Read Long Write Long

Gerry Houlder
Seagate Technology

Read Long / Write Long Proposal

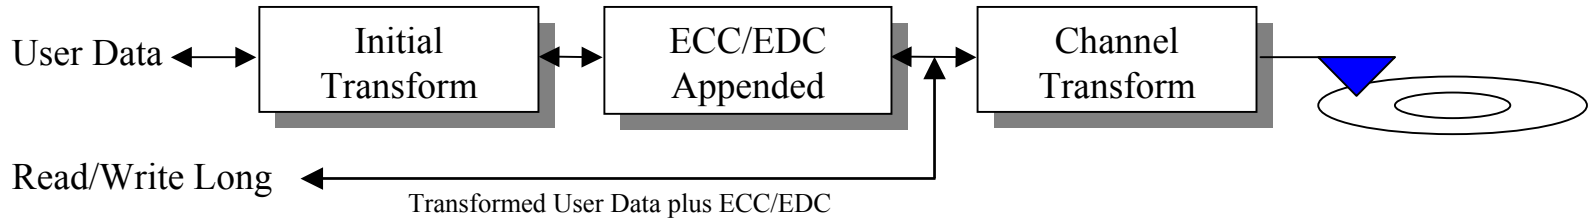
Previous Standard Usage

New / Potential Standard Usage
